ADDENDUM # 1

SUBJECT: B0001597 Addendum – Heskett Center eSport Remodel

STATE OF KANSAS
CONSTRUCTION PROJECT NO. A-013730

Wichita State University
eSports Gaming Project
Wichita, Kansas

M201

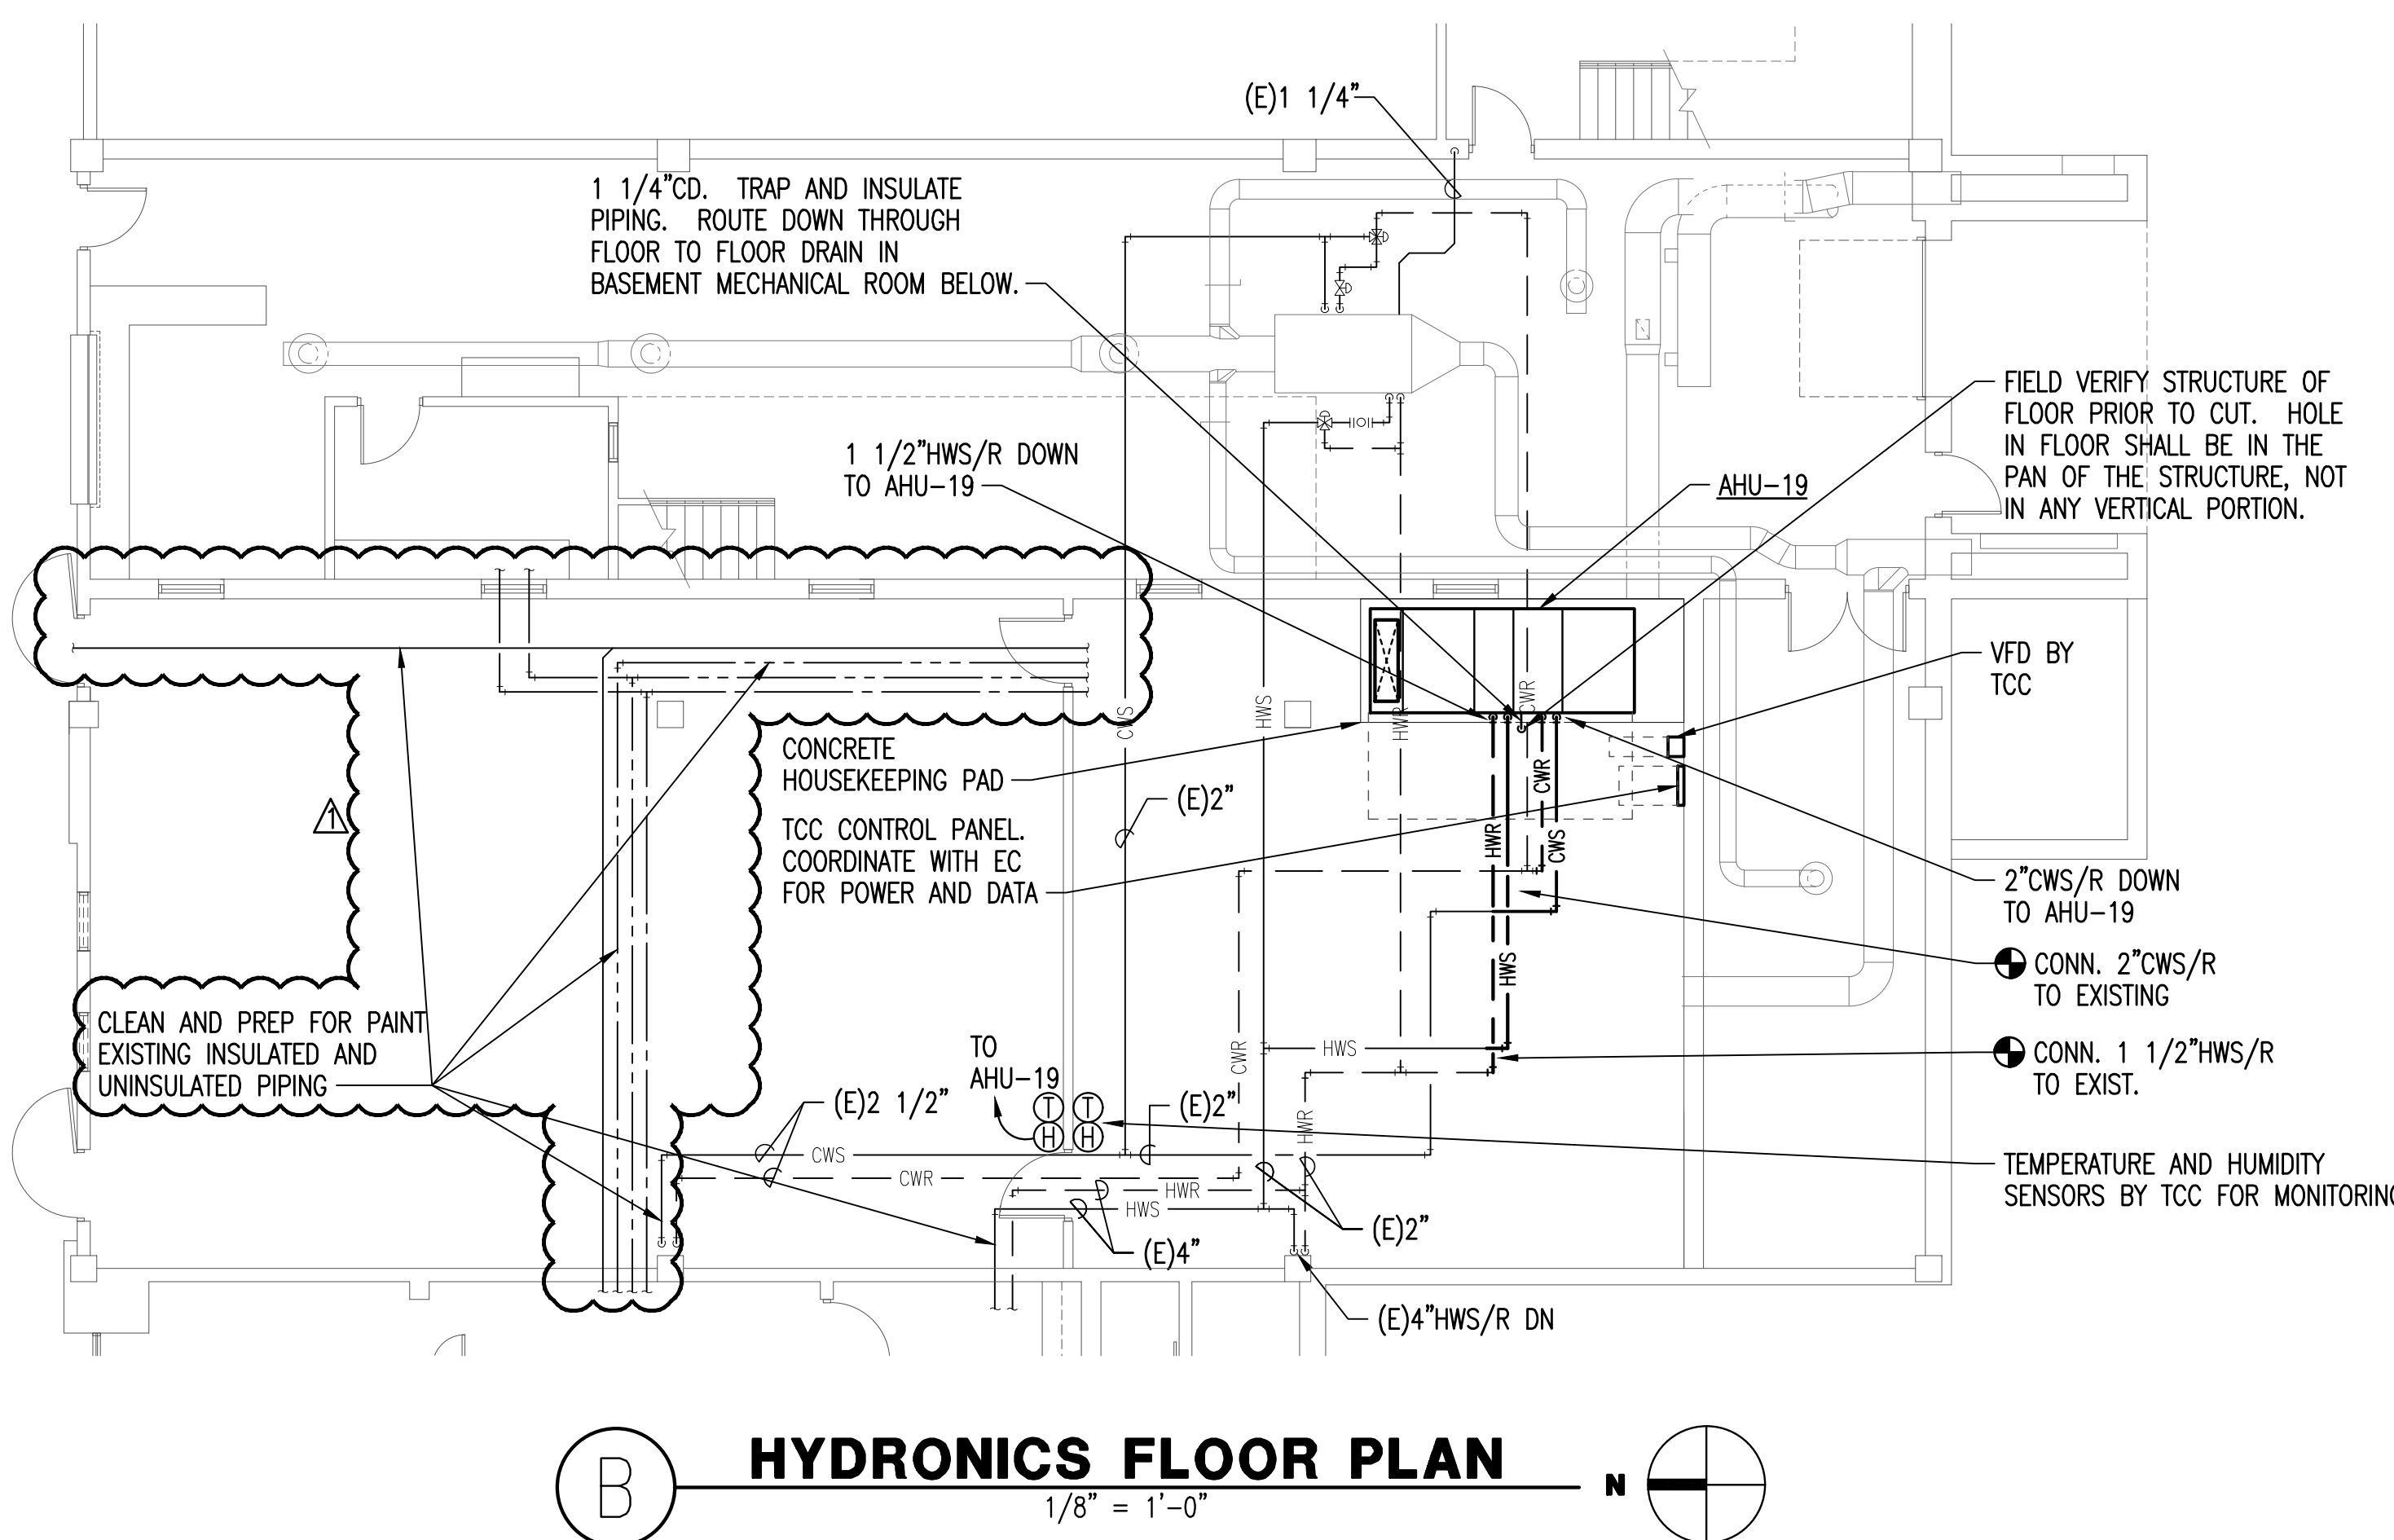
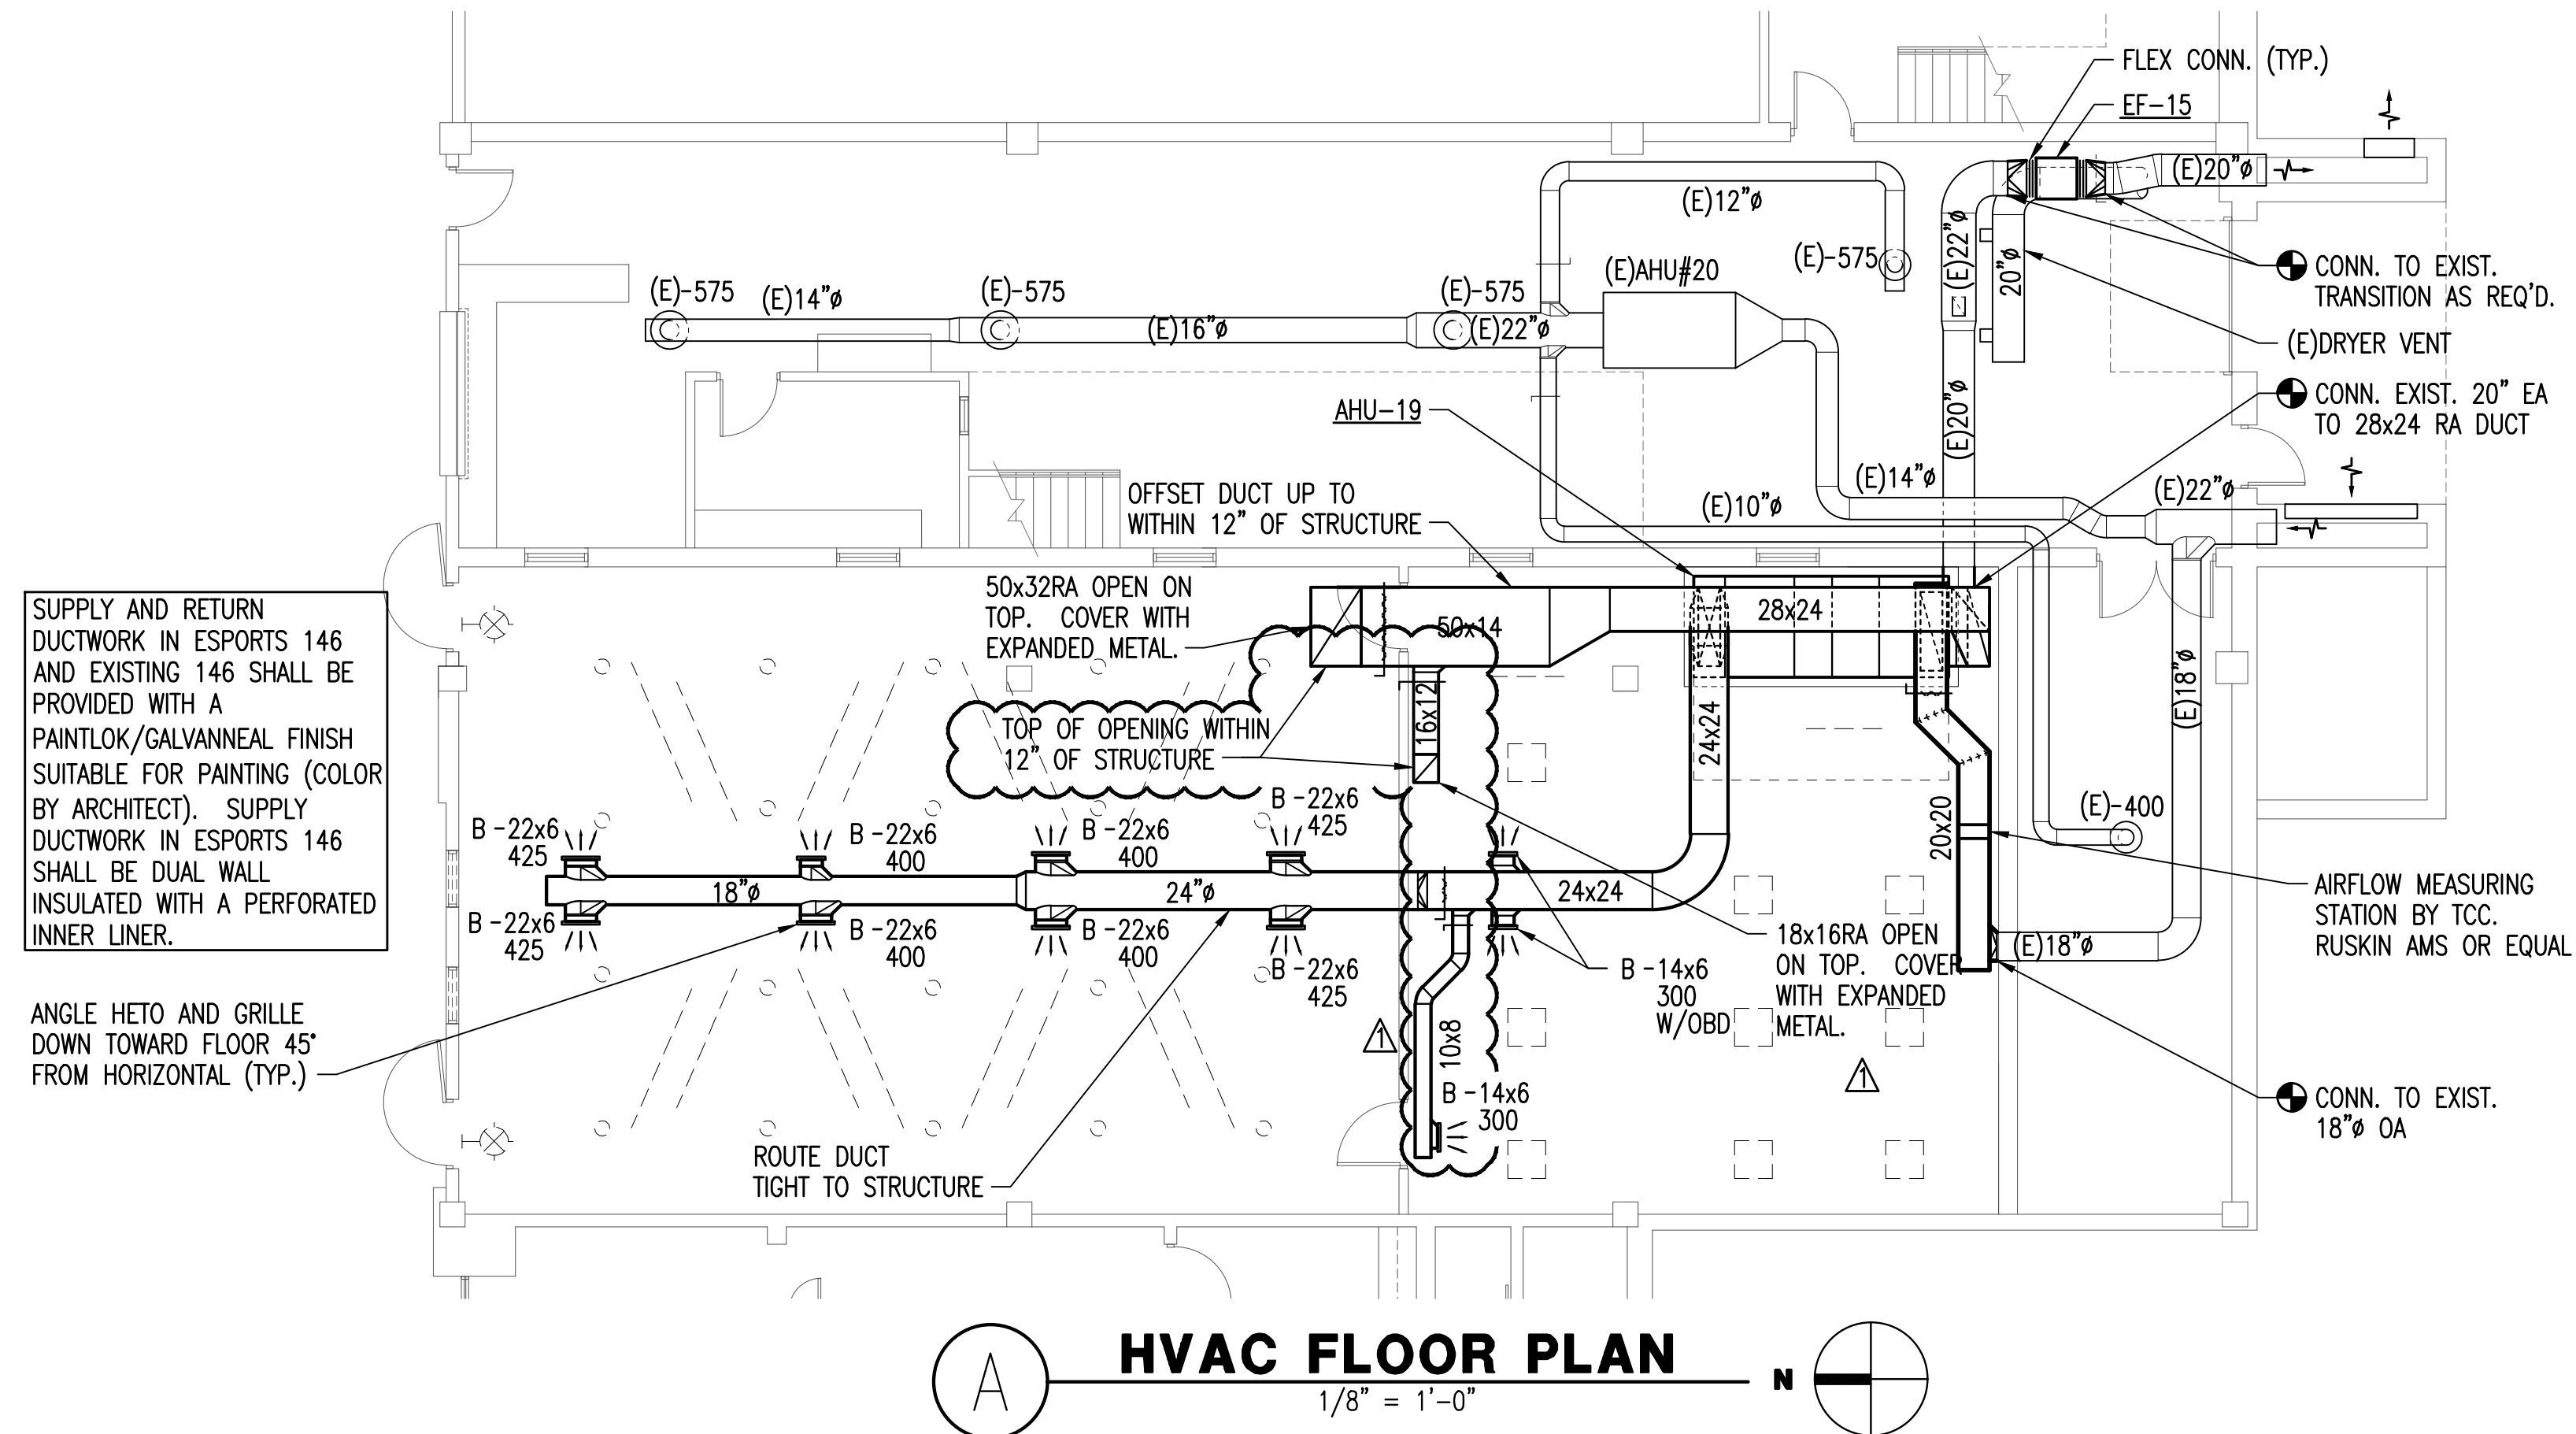
- A. Added a Return Air opening for Existing 146A. Refer to revised drawing.
- B. Relocated a Supply Air duct serving 146A. Refer to revised drawing.
- C. Included general location of existing piping to be cleaned and prepped for paint.
